#### The Friends of Warnham Local Nature Reserve

20 October 2020

# Response to HDC's Revised Rookwood Proposal

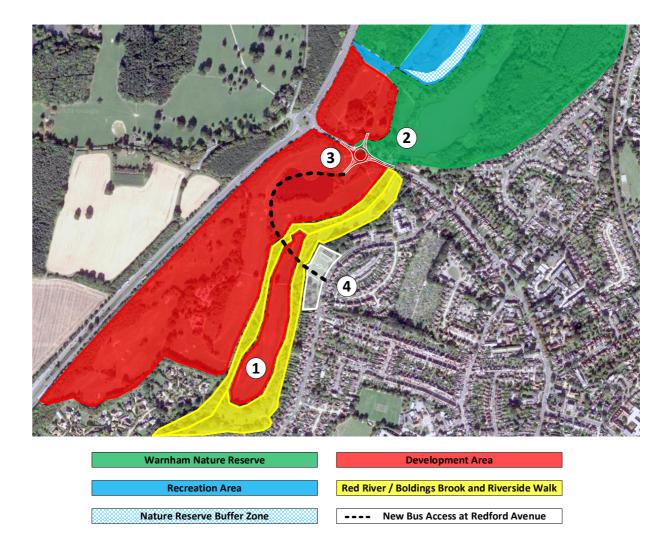
The Reserve does not exist in isolation; Rookwood Golf Course is part of its essential support network. The revised proposal shows that, overall, about 50% of the combined Reserve plus Rookwood land will be given to development, which significantly reduces the amount of green space and space devoted to lakes, e.g. at least 60% of Rookwood lake will be lost.

Of particular concern is the new intention to build on "Fairway 15" (Tulip Tree) which is in the middle of the Red River / Riverside Walk / Boldings Brook area (label 1 below). This area was originally to be retained as green recreation space but will now be built on.

HDC's Rookwood Ecology Constraints Plan<sup>2</sup> shows that the Boldings Brook and Red River corridors are "Habitats of Principal Importance". However, the revised proposal now builds on both sides of the Red River, and right up to the west side of the Riverside Walk and Boldings Brook. In addition, the new bus route passes across both rivers and the Riverside Walk causing further disruption to the area's ecology.

The rivers are blue and green corridors that support the Reserve, for example, kingfishers are known to nest in the steep banks of the Red River and to hunt over the Reserve. Building as proposed will damage these areas and will consequently compromise the Reserve. It is our view that fairway 15 must be left green if HDC choose to develop the southern land.
